**AGENDA**  
**CASCADE CHARTER TOWNSHIP PLANNING COMMISSION**  
**MONDAY, May 19, 2025**  
**6:00PM**  
**2870 JACKSMITH AVE SE**

**Case #25-3885 – Public Hearing**

## PLANNING COMMISSION STAFF REPORT

STAFF REPORT: Case # 25-3885  
REPORT DATE: May 14, 2025  
PREPARED FOR: Cascade Charter Township Planning Commission  
MEETING DATE: May 19, 2025  
PREPARED BY: Andrea Hendrick, Community Planning & Development Director

Sheet title:  
**PLAN DETAILS & SITE STRUCTURE**

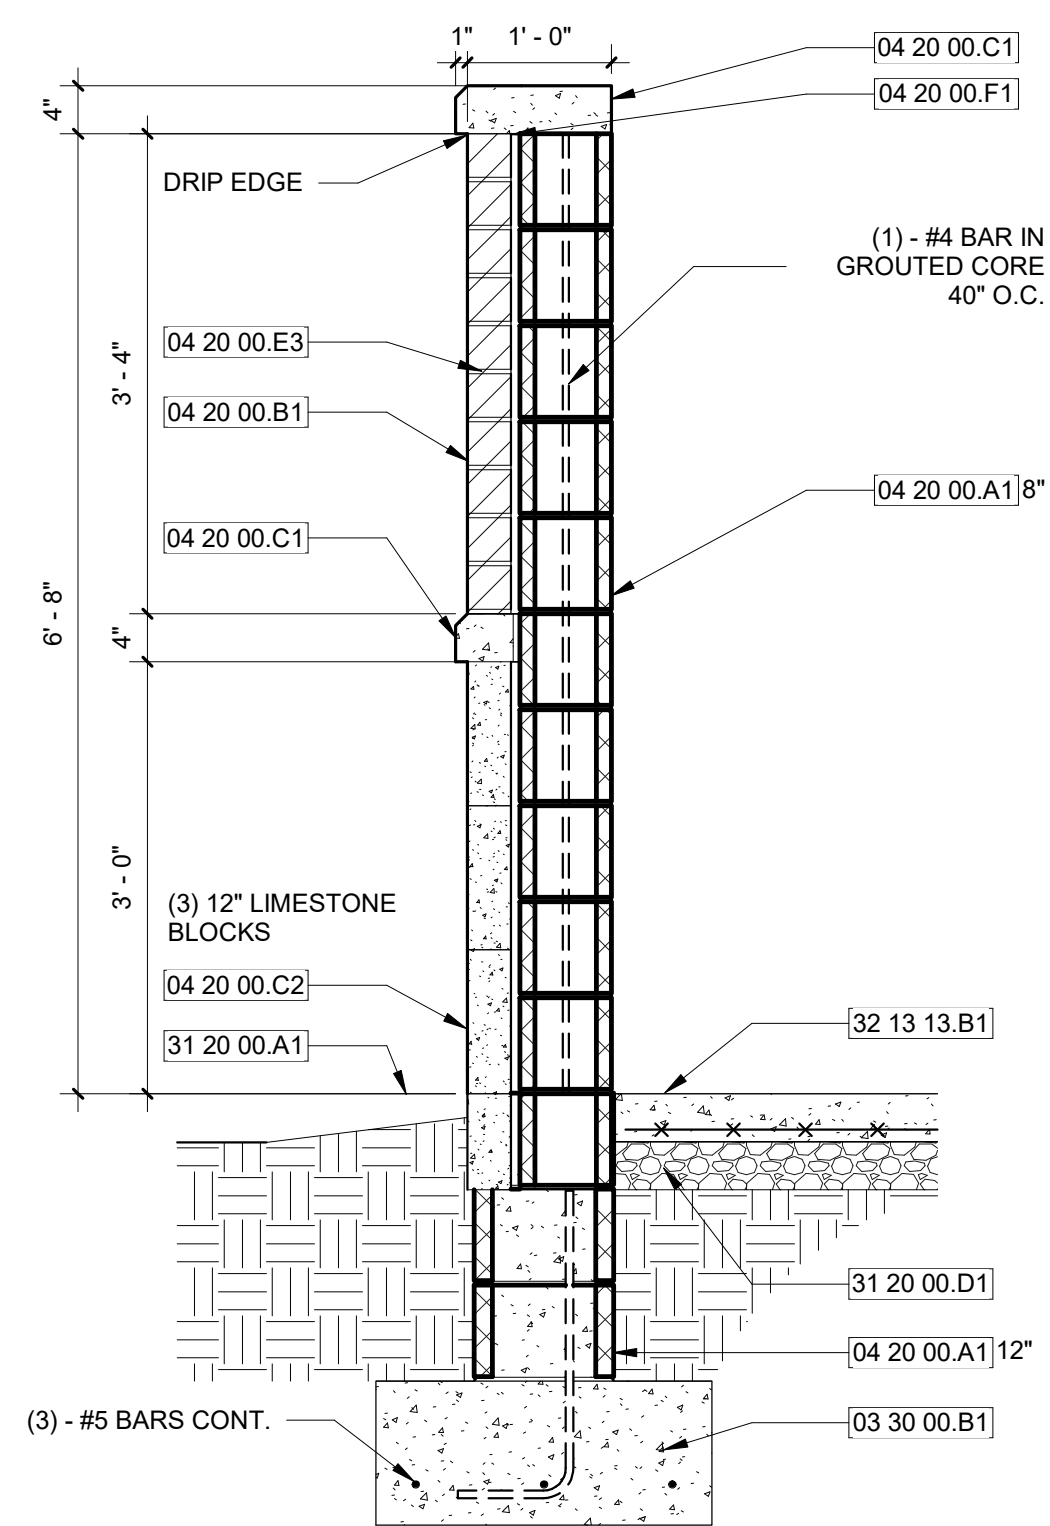
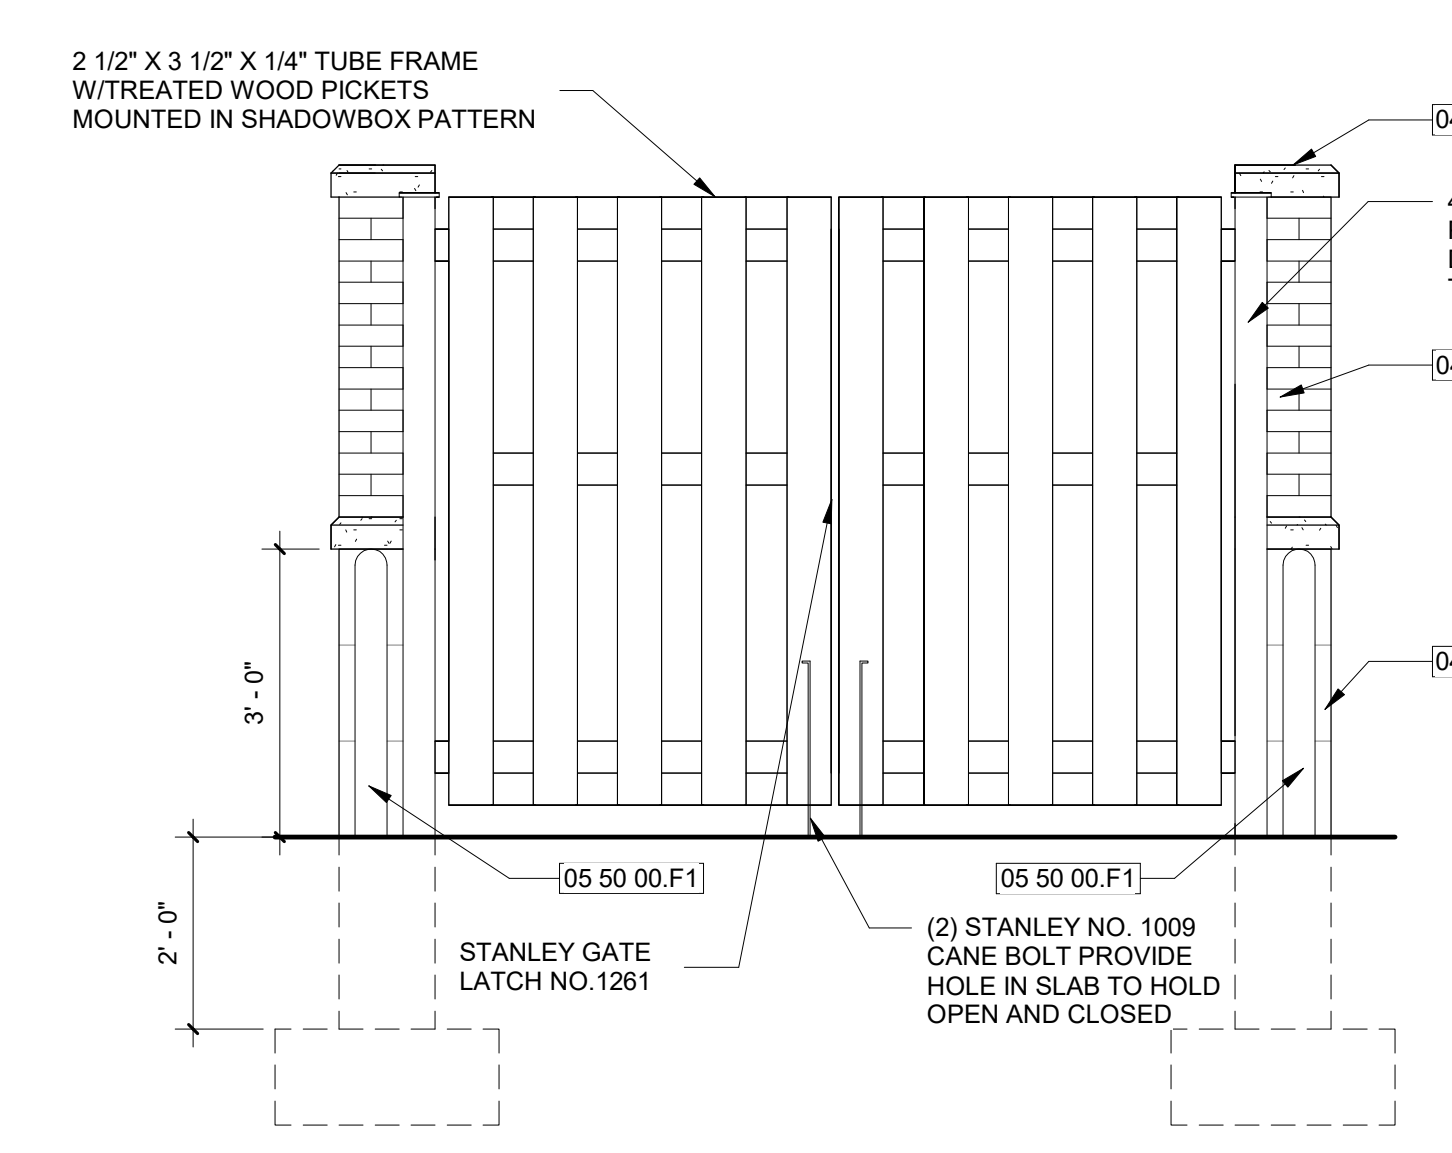
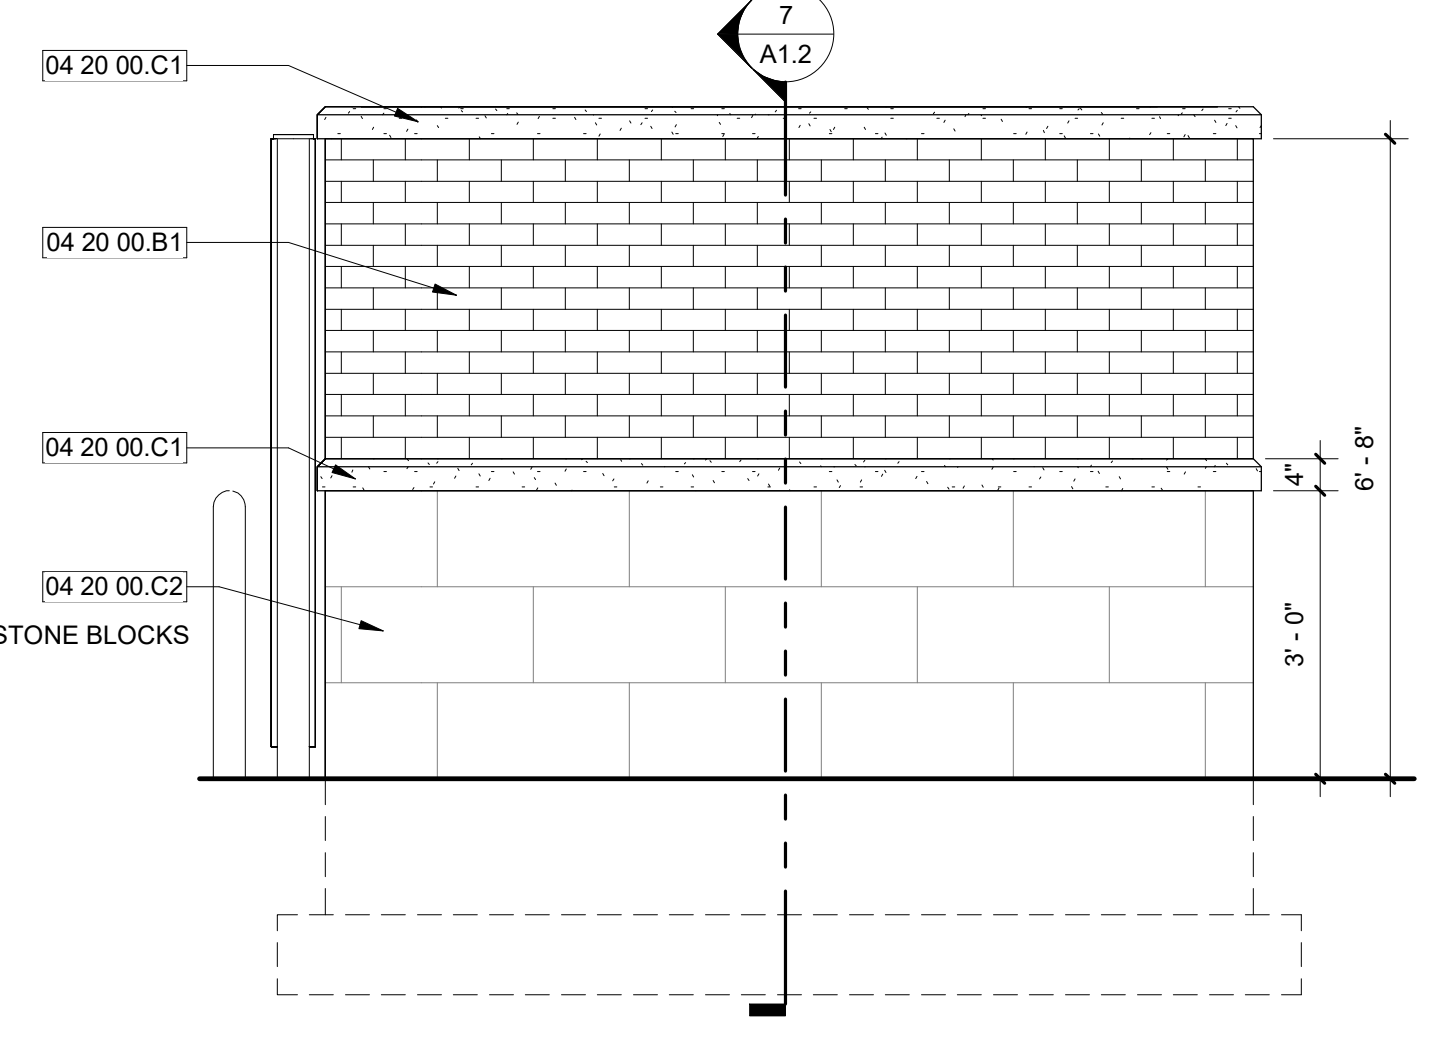
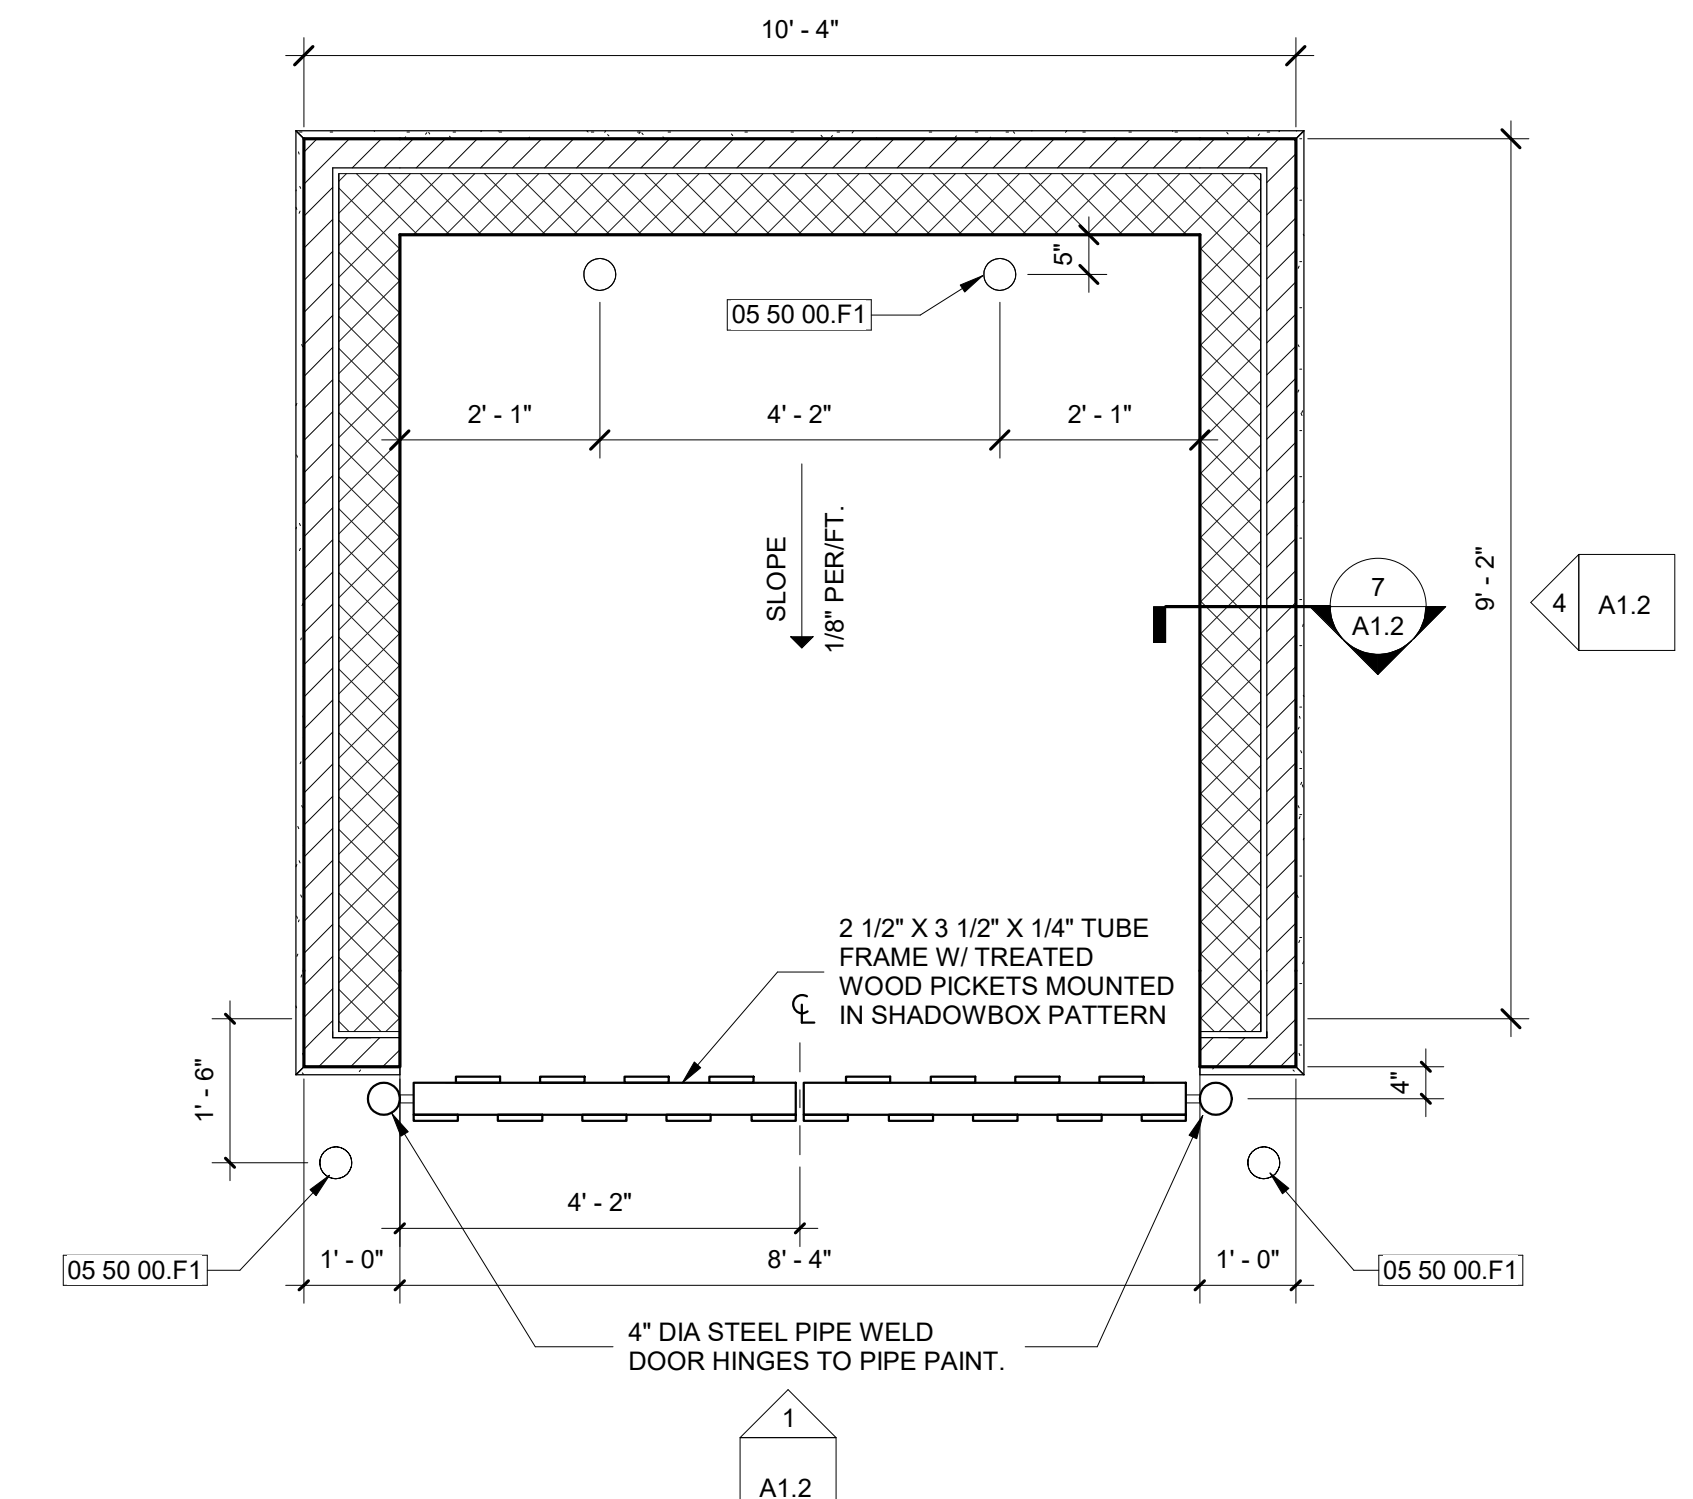
<p>7. Dumpster Enclosure</p>	<p>The applicant has not met the requirements for dumpster enclosures as stated in Section VI.7.c. of the Centennial Park Overlay. The Ordinance does not provide the Planning Commission with an option to wave this requirement. Staff recommends that the Planning Commission condition that this standard is met.</p> <p>The applicant has options modifying the dumpster:</p> <ul style="list-style-type: none"> <li>• Seeking a variance from the ZBA</li> <li>• Administrative approval if this requirement is excluded from the Zoning Ordinance when it is amended later this year. The draft ordinance will be presented to the Planning Commission in June 2025.</li> </ul>
<p>8. Lighting</p>	<p>The applicant has presented a photometric plan with lighting levels that exceed the maximum allowed brightness. Staff pointed out the discrepancy and requested the plans be modified to meet the standard. The current submission documents still include a lighting plan with levels exceeding allowed levels. However, the applicant has also provided a “dimmed” lighting plan labelled E7.2A. This plan also has lighting levels that exceed allowed levels. The applicant proposes to dim the lights during unoccupied times. This is not compliant with the Zoning Ordinance.</p> <p>Currently, the Planning Commission does not have the authority to increase allowed lighting levels. Proposed amendments to the Zoning Ordinance will allow the Planning Commission to increase lighting levels in circumstances where doing so will increase public safety. The applicant may be able to utilized this path in the future.</p> <p>Currently, if the applicant desires to increase lighting to levels that exceed maximum level, the applicant can pursue a variance from the Zoning Board of Appeals. It is also worth noting that the ZBA heard a request on 05-13-2025 for this request for a bank located on 28<sup>th</sup> Street. The request was denied.</p>
